# ACOUSONDE™ ATTITUDE/HEADING AXIS CONVENTION UPDATE

Model B003A and B003B

Firmware version 2.0.14, PalmOS client software version 2.0.3  
January 2011

**GREENERIDGE SCIENCES, INC.**

**Figure 1. Acousonde accelerometer and compass axes as configured in 2011.**

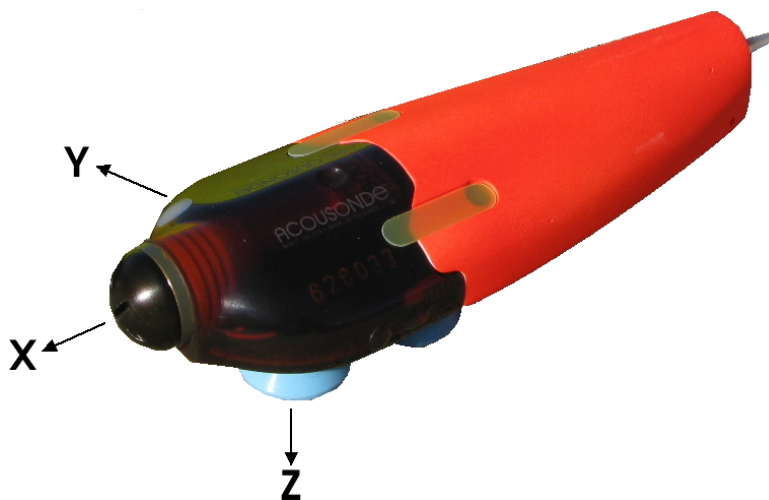
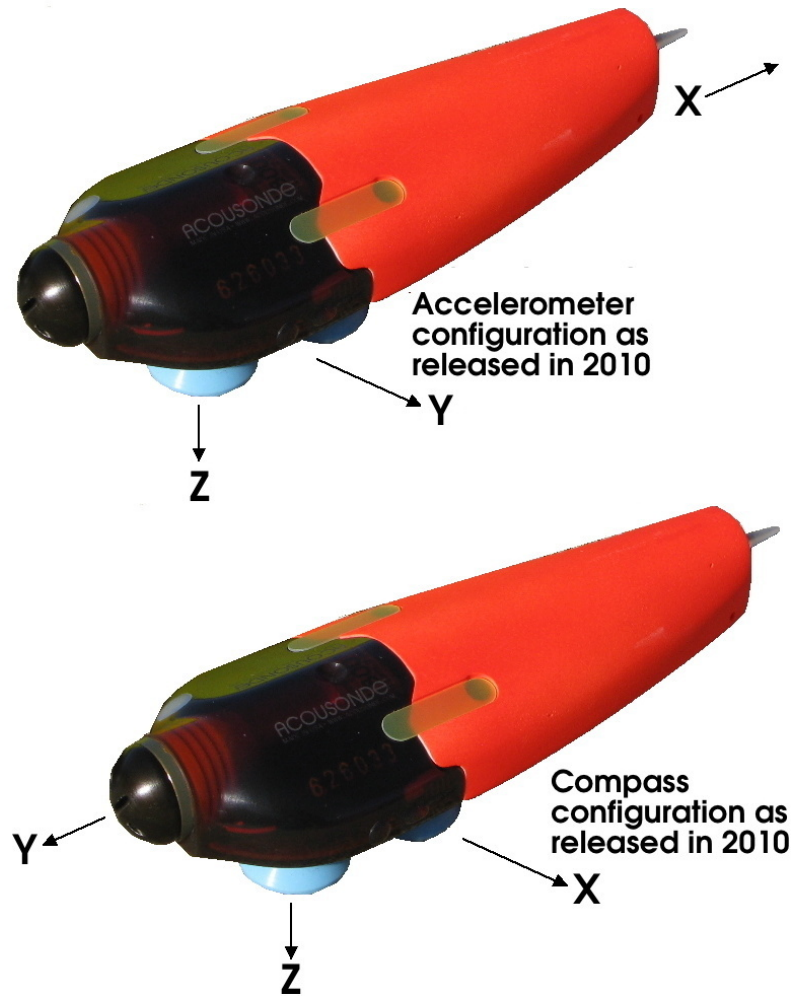
Marine navigation systems typically adopt the “north, east, down” reference-frame convention to represent attitude and compass heading. Acousonde units released in 2011 and after use axis conventions optimally compatible with this standard (Figure 1).

Alignment of the compass X, Y, or Z axes towards north yields positive samples in the corresponding channel. Samples from the X channel will be near maximum when the Acousonde points north; from the Y channel when the Acousonde points west; and from the Z channel when the Acousonde’s bottom points north.

Accelerometer X, Y, and Z\* channels yield positive samples when the device is accelerated in the corresponding direction. Since gravity is equivalent to acceleration away from the Earth, it will induce positive samples on X when the Acousonde is pointed up; on Y when the Acousonde is positioned horizontally on its left side (i.e. 90° left roll); and on Z when the Acousonde is upside down.

Acousonde units released in 2010 and before use alternate axis definitions (Figure 2). Acoustimetrics recommends that all pre-2011 units be updated for maximum compatibility. Updating may be less important for users who foresee no kinematic applications.

**Figure 2. Acousonde accelerometer and compass axes as configured prior to 2011.** Units released in 2010 or before that have not been updated use this axis configuration, now deprecated in favor of that shown in Figure 1.
